EXHIBIT A DEPARTMENT REVIEWS

**Vista 600
Site Plan**

VISTA 600 WEST
13645 SOUTH 600 WEST
DRAPER, UTAH

C-101

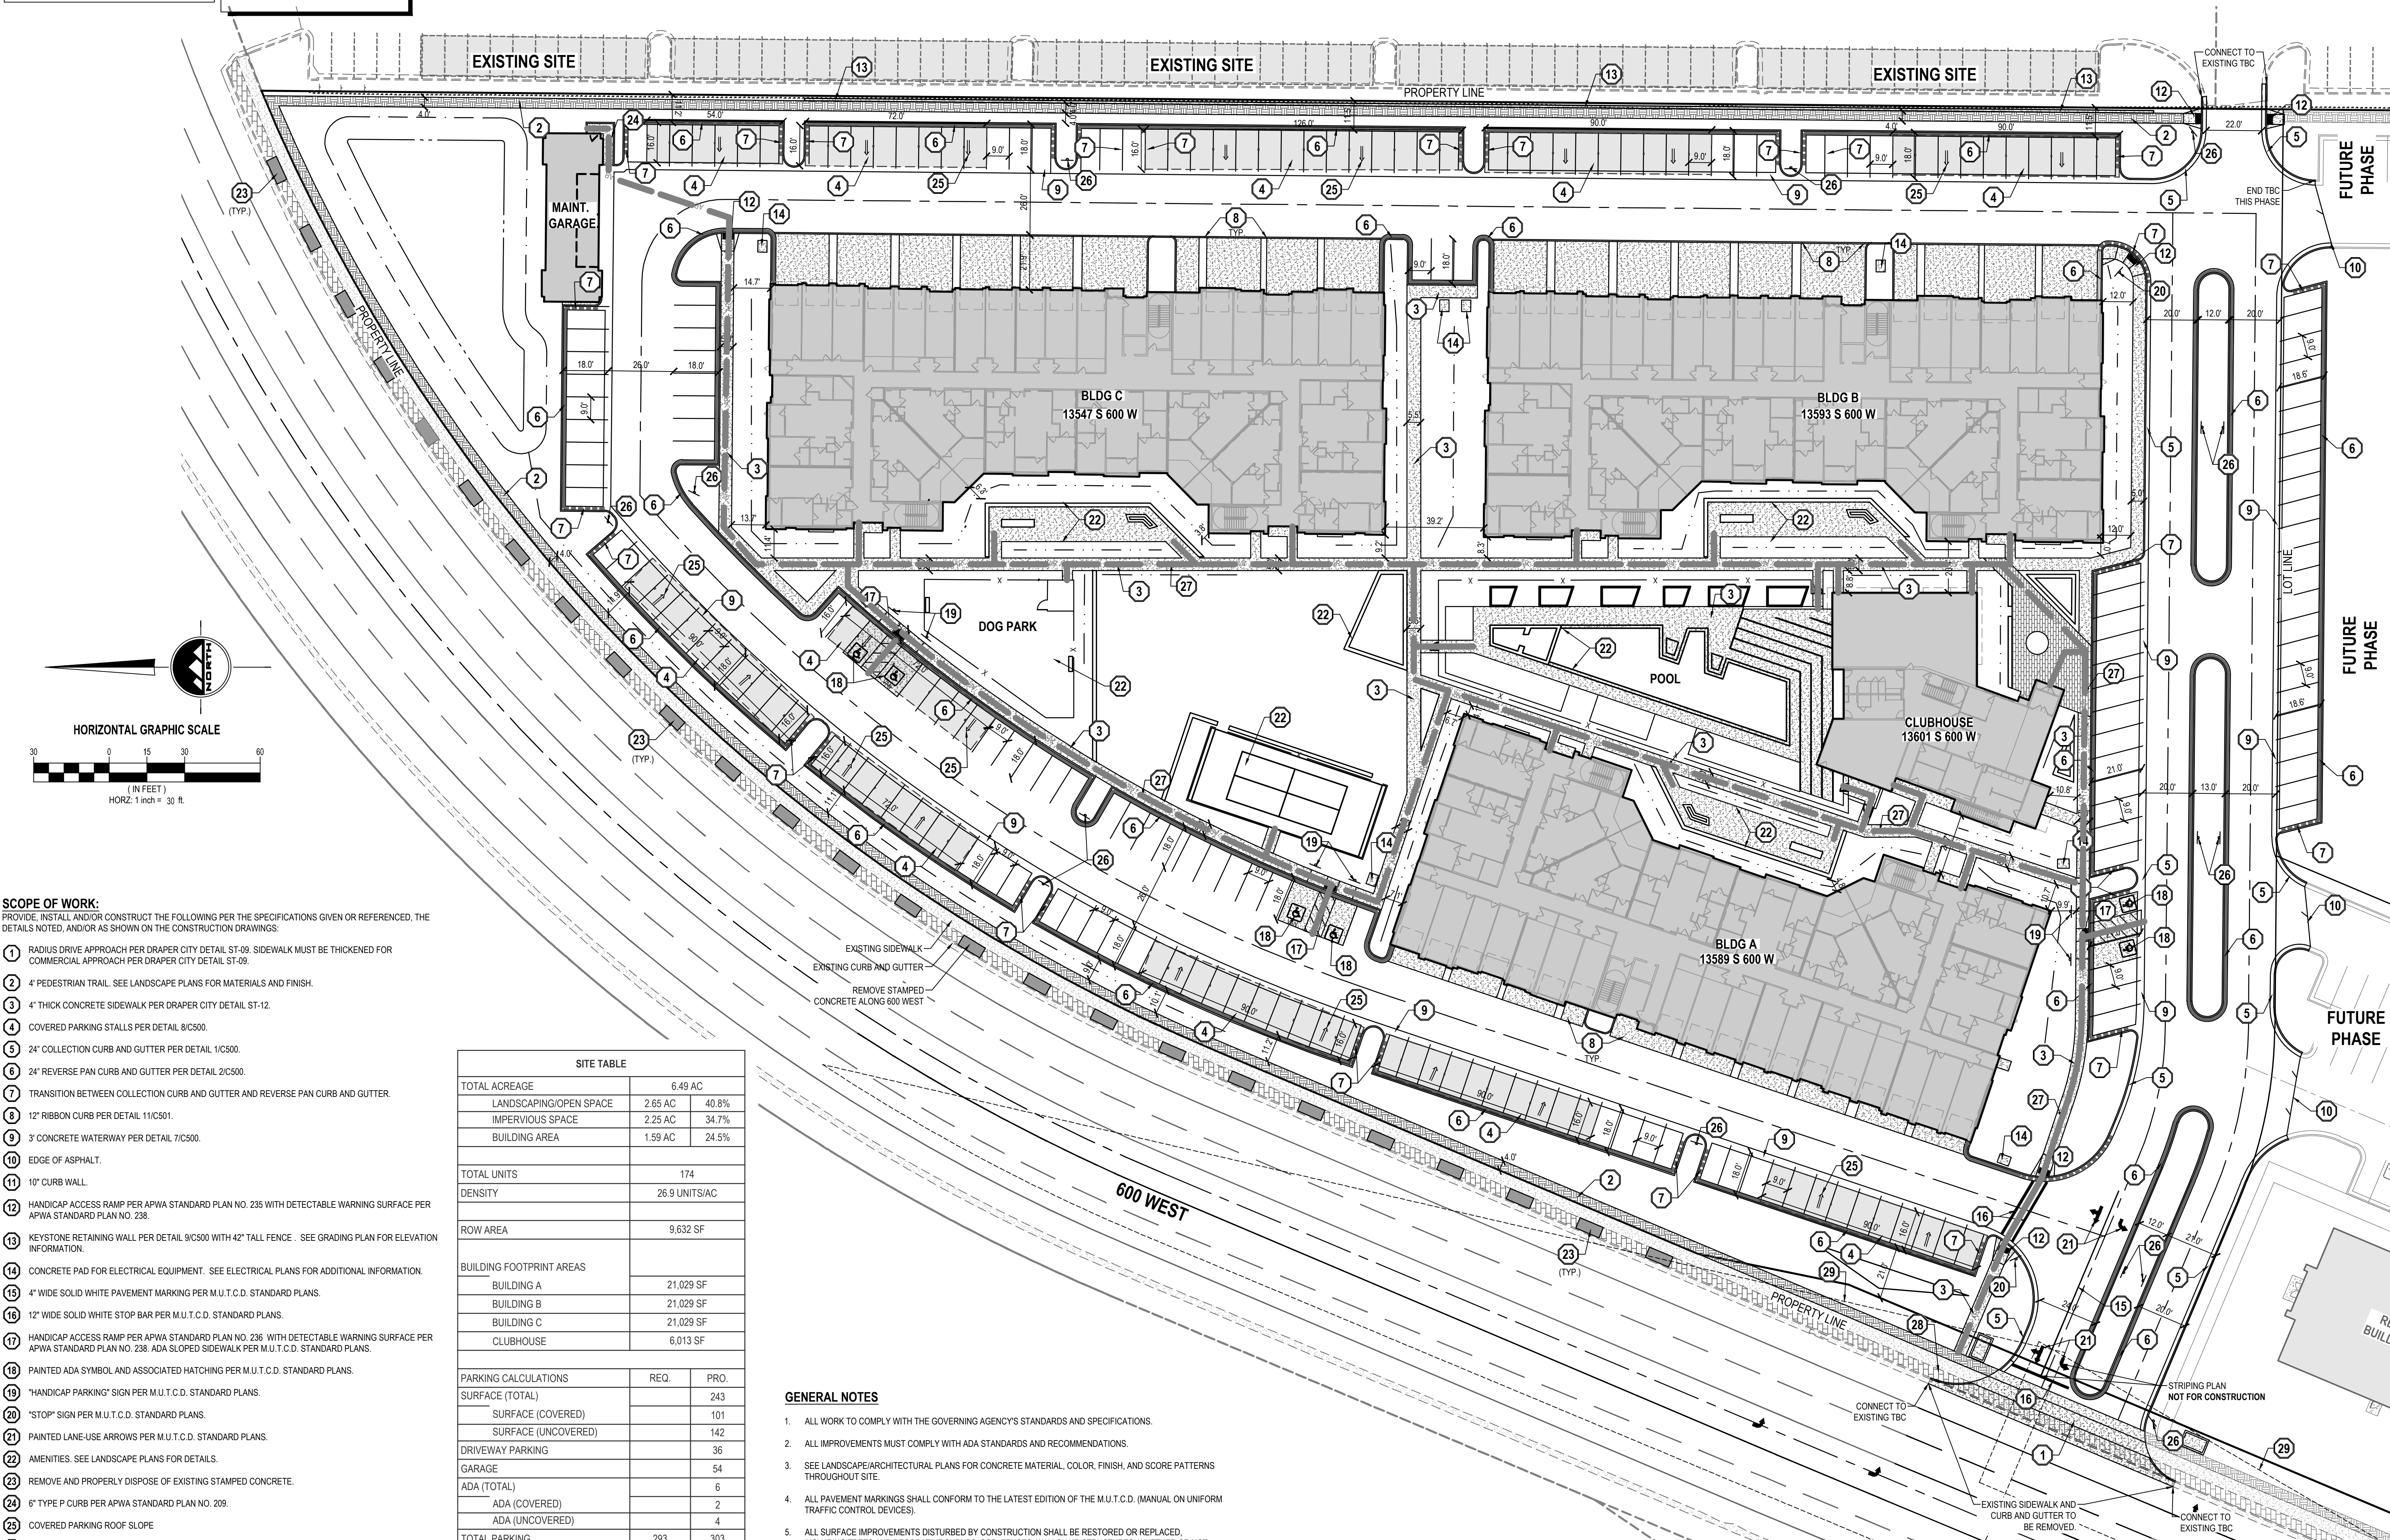
6. Any work in the public right-of-way will require an Encroachment Permit obtained through the Engineering Division.
7. Drainage Plan (C-203) shows 24-inch diameter pipes from control structure where detail 10 on C-501 shows 18-inch diameter pipes. Clarify.

8. Move connection point to 16-inch waterline northward so the master meter is inline with the tap. The fire line can then bend to the private drive isles once across the sidewalk. The future meter vault and stub through the vault will be the only connect with a bend between the tap and the vault.

9. Fire line is extended east to adjacent development. Written permission is required for connection and construction to be completed on adjacent site. No adjacent owner written permission received with third submittal.

SHEET:
E1.3

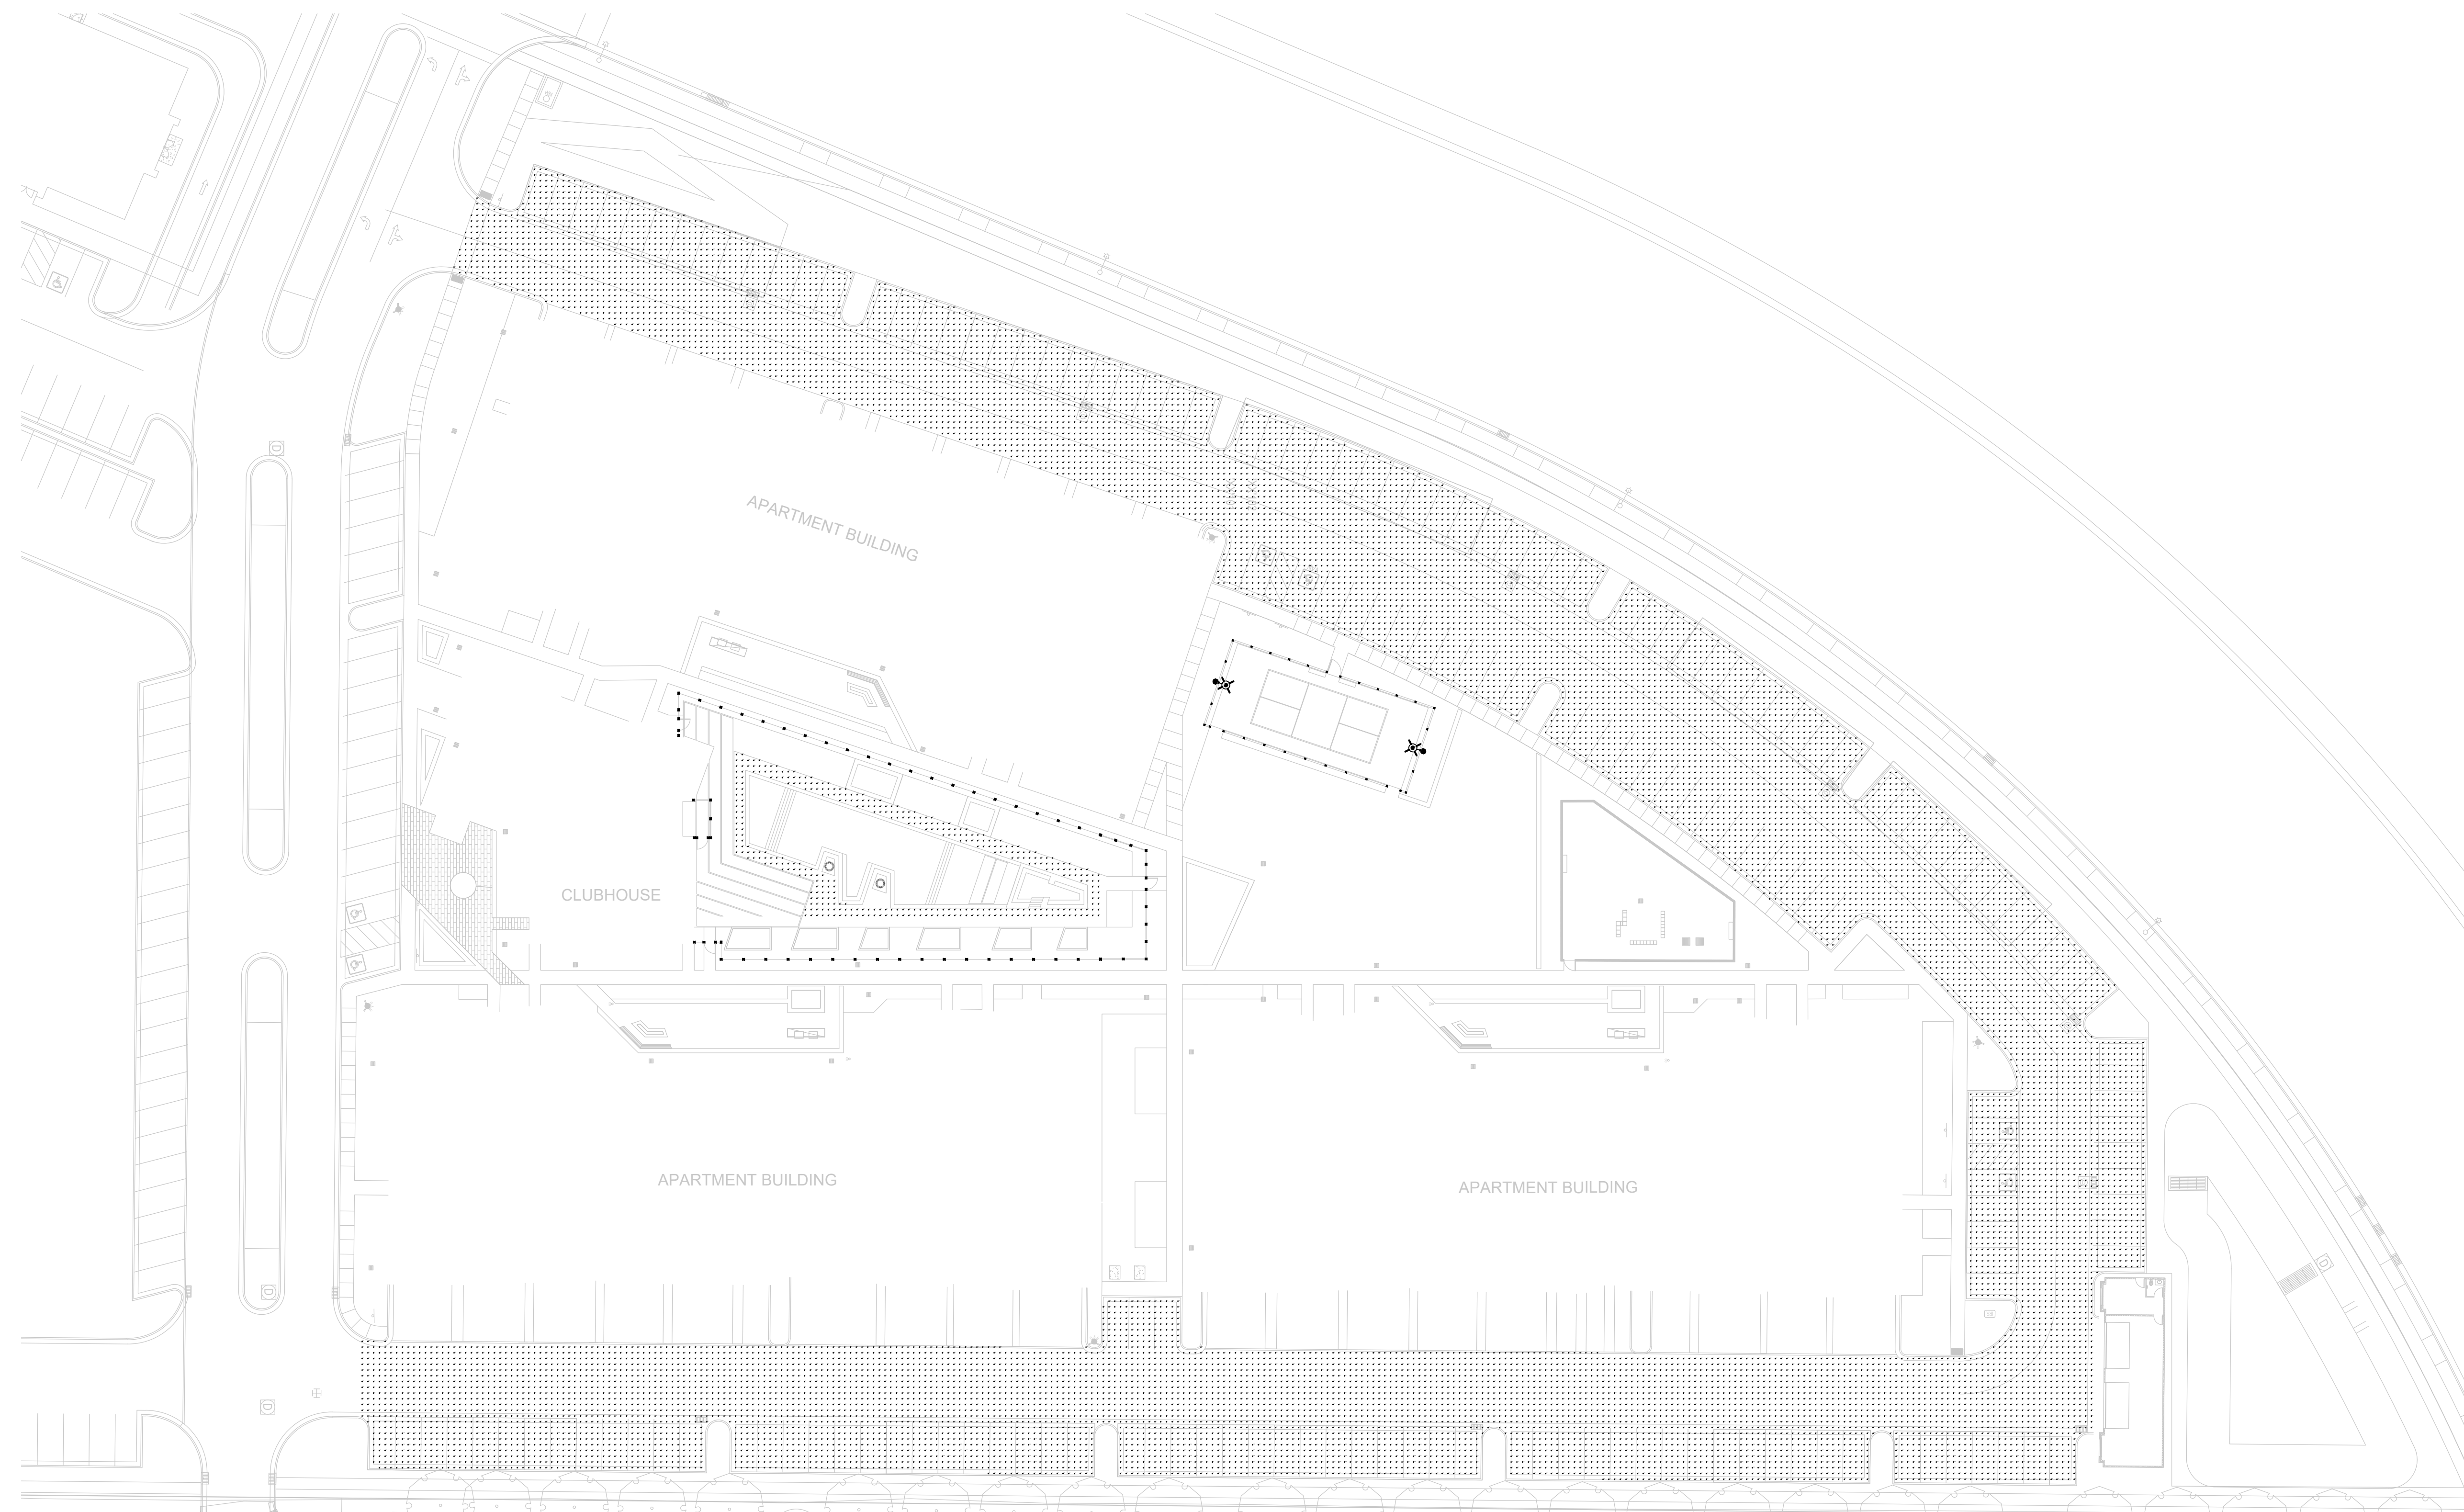
Lighting. The adopted MAP contains minimum standards for lighting of which there are six standards. The applicant has provided a lighting and photometric plan (Exhibit I) which has foot candle readings between .5 to 4.0 and light poles that do not exceed 30 feet in height. Low level bollard lighting has been provided for the internal pedestrian walkways.
